SR 9 SIDEWALK & DAHLONEGA WATER MAIN PROJECT #2021-007

ADDENDUM 1

Addendum Subject: Responses to Contractor Questions; Revised Attachment D and Contract

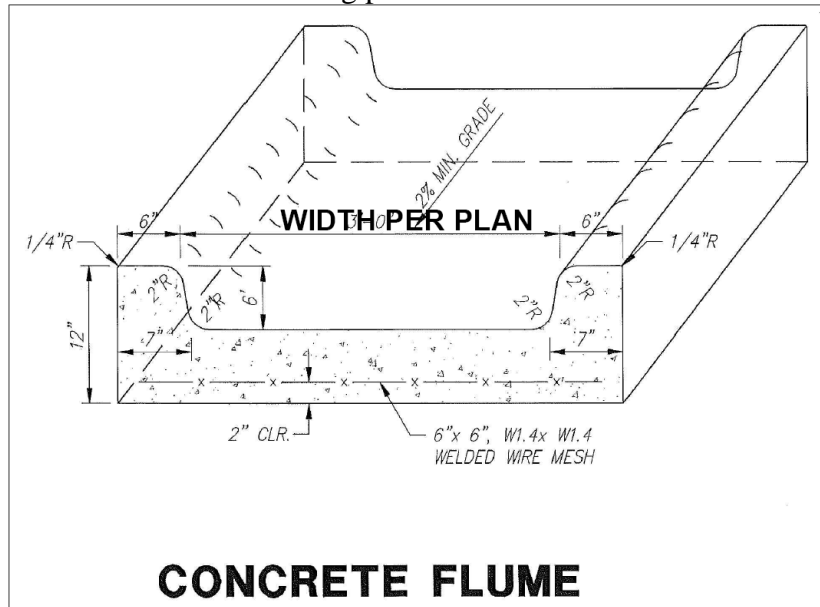
2. Bid item 0125 is for 8" white traffic stripe. How will the 5" solid white be paid? **See amended Attachment D and Contract Pricing Sheet for added line item for 5" solid white thermo striping.**
3. Bid Item 0130 – sidewalk over flume with the detail of sheet 15 calls for the reinforced section of sidewalk. What is the detail for the remaining part of the flume? **See detail below.**

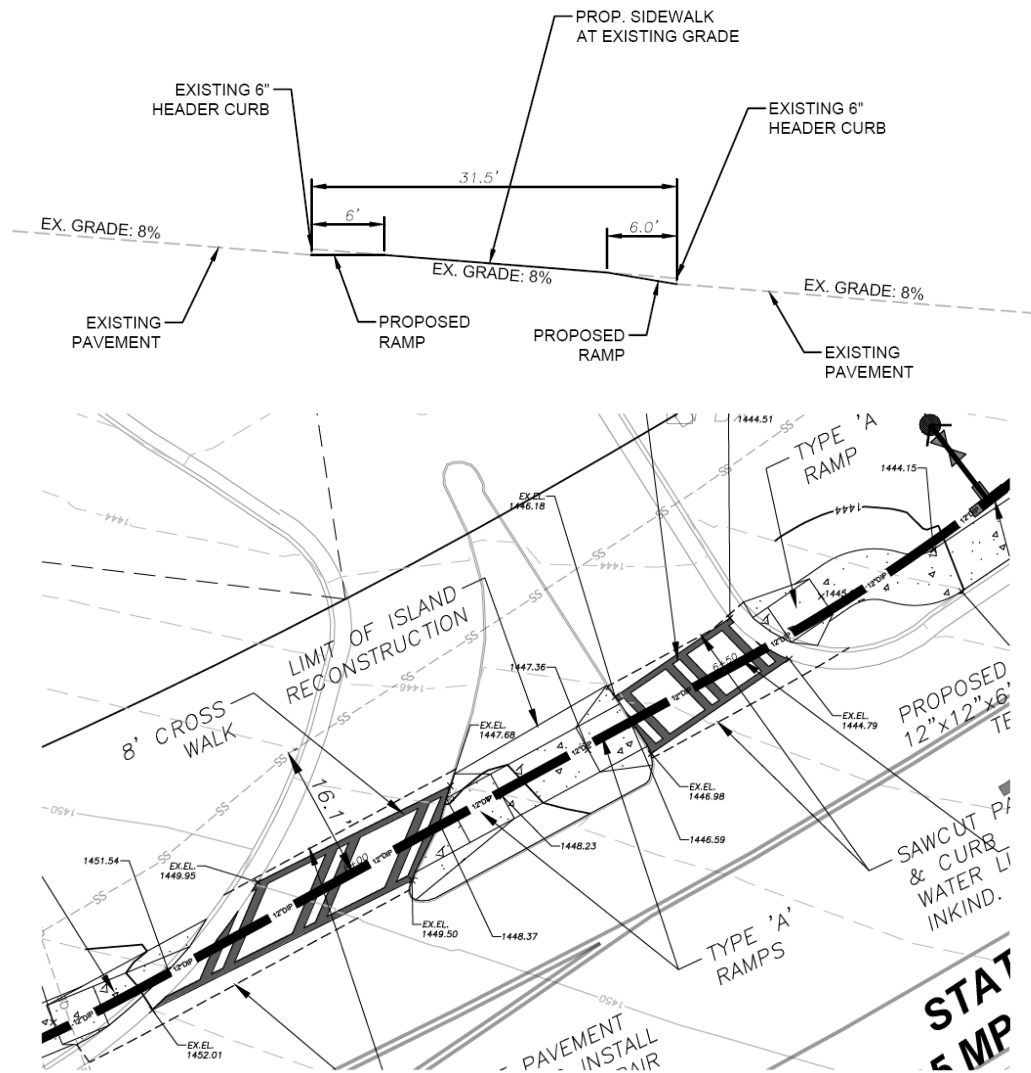
14. Can a Section be provided for the replacement required at the Bank concrete Island? See below for the profile view and a blow-up plan view with the limits of replacement concrete defined. Concrete sidewalk will need to be constructed so that the cross slope is no greater than 2% and then slope back down to existing and the limits proposed.
